# UNITED STATES PATENT AND TRADEMARK OFFICE

APPLICATION NO.	FILING DATE	FIRST NAMED INVENTOR	ATTORNEY DOCKET NO.	CONFIRMATION NO.
09/347,845	09/30/1999	YI YANG	243/079	4401

# Office Action Summary

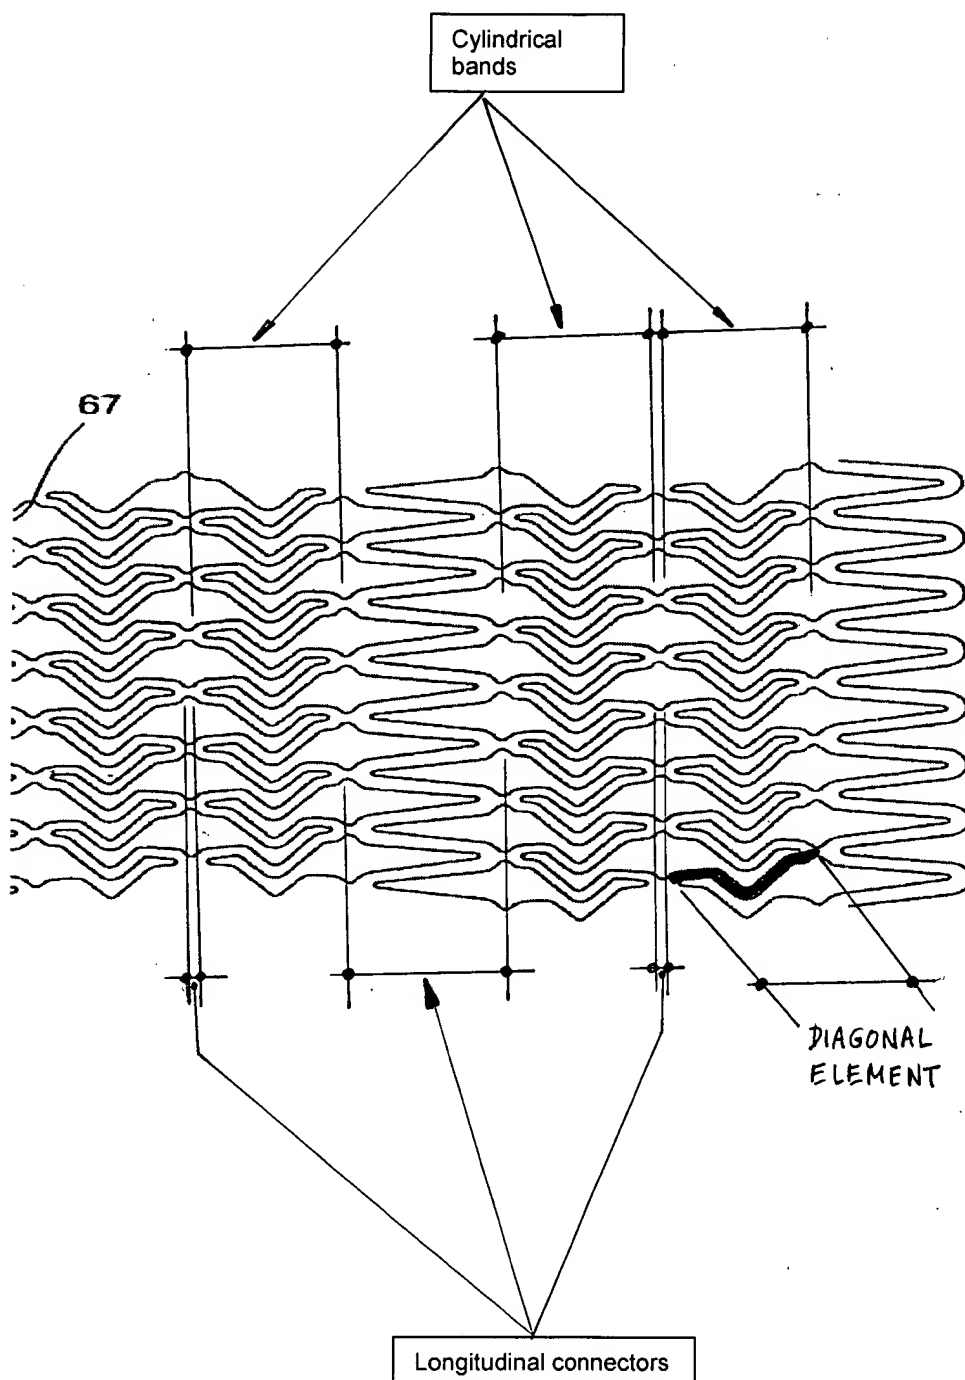
As to claims 1, 3-4, 8-11, and 24-25, VON OEPEN (Fig. 8 as reproduced and shown on **page 5** of this paper and see column 1, lines 36-39, VON OEPEN) discloses a **non-sinusoidal** zigzag pattern tubular stent (60) expandable from a contracted condition for easy introduction of the stent into a body lumen (a blood vessel) to an enlarged condition for supporting and keeping the body lumen (the blood vessel) open. Inherently, the stent is biased from a contracted condition either by a balloon or by a self-expanding property of the stent material towards an enlarged condition (as recited in claims 4, 24-25) to support the body lumen. The stent comprises:

- **A central portion consists essentially of a series of cylindrical bands, each band comprises a generally non-sinusoidal zigzag pattern of diagonal elements having generally arcuate shapes, arbitrarily assigned either a clockwise or counter clockwise orientation. Notice that the central portion consists essentially**

of a series of cylindrical bands because the central portion includes a majority of cylindrical bands .

- A plurality of straight and short or long connectors (I-shaped labeled as elements 66, 67) extending substantially parallel to the longitudinal axis of the stent. Notice that in a contracted configuration during deployment of the stent, connectors 66, 67 are squeezed closed one to each other and connectors 66, 67 are substantially parallel to the longitudinal axis of the stent.

- The short longitudinal connectors have a longitudinal dimension substantially smaller than a longitudinal dimension of the diagonal elements (as recited in claim 9). The diagonal elements comprise 1<sup>st</sup> and 2<sup>nd</sup> generally straight portions having 1<sup>st</sup> ends connected to preceding and succeeding diagonal elements and 2<sup>nd</sup> ends being connected together (as recited in claim 10).

- The diagonal elements of each cylindrical band are out of phase with any adjacent cylindrical band (as recited in claim 11).

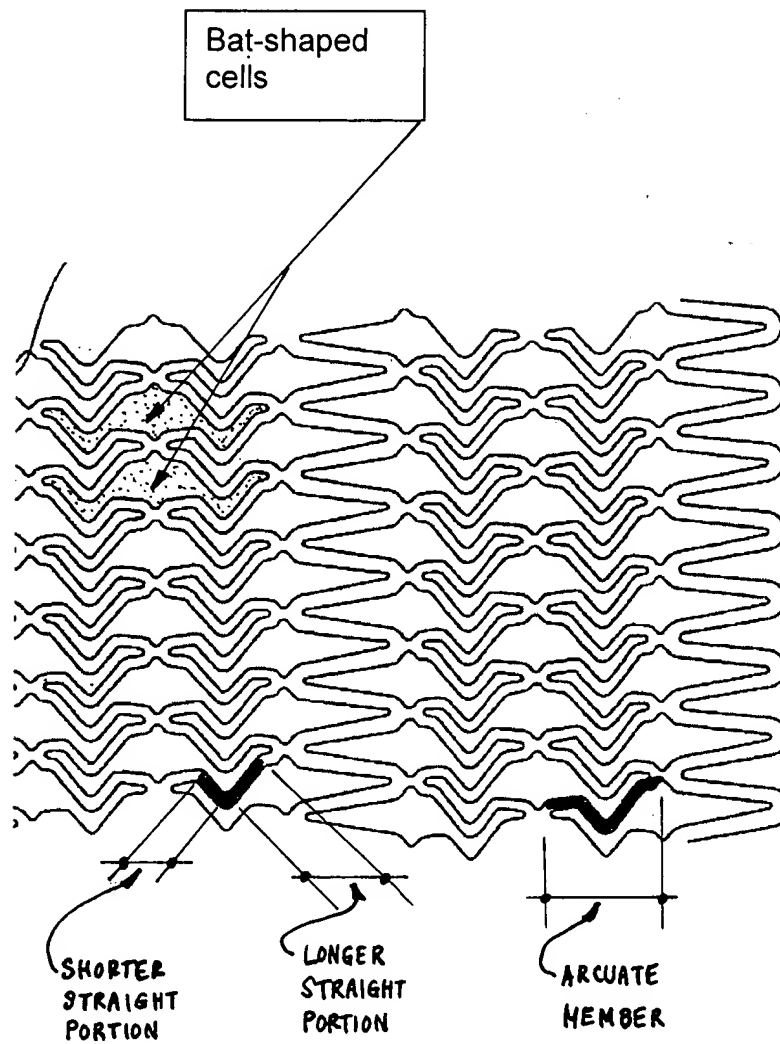
As to claims 12-15 and 17-22, VON OEPEN (Fig. 8 as reproduced and shown on **page 6** of this paper; see column 1, lines 36-39, VON OEPEN) discloses a tubular stent (60) comprising:

- A central portion consist essentially of a plurality of bat-shaped cells formed from **non-sinusoidal** cylindrical bands each cell having a head region, a tail region and opposing curved wing regions. The central portion consists essentially of a plurality of bat-shaped cells because there are a majority of bat-shaped cells in the central portion.
- A plurality of **straight short and long** connectors (I-shaped) extending substantially parallel to a longitudinal axis (as recited in claims 12 and 15) and

connecting each of the adjacent cells. Notice that in a contracted configuration during deployment of the stent along a blood vessel, connectors 66, 67 are squeezed closed one to each other and connectors 66, 67 are substantially parallel to the longitudinal axis of the stent.

- The head and tail regions are aligned about the circumference of the stent, the wing regions have a generally V-shaped extending longitudinally away from the head and tail regions (as recited in claim 13).

- The cells are arranged sequentially about the circumference, thereby defining a cylindrical band (as recited in claim 14).
- The wing regions are defined by 1<sup>st</sup> and 2<sup>nd</sup> arcuate members, the 1<sup>st</sup> and 2<sup>nd</sup> arcuate members comprising a pair of generally straight portions connected to one another by a curved portion, and the curved portion defines an apex of the "V" shape curved wing regions, the apices all pointing substantially in a single direction (as recited in claims 17-18).

- The head regions and tail regions are defined by longitudinal connectors (I-shaped connectors), one of the straight portions of each of the first and second arcuate members is substantially shorter than the other generally straight portion of the respective arcuate member, and the longitudinal connectors define the tail region also define the head region of an adjacent cell (as recited in claims 19-21).

- The connectors comprise a longitudinal connector (V-shaped connector) extending between a wing region of a first cell and a wing region of an adjacent cell (as recited in claim 22).
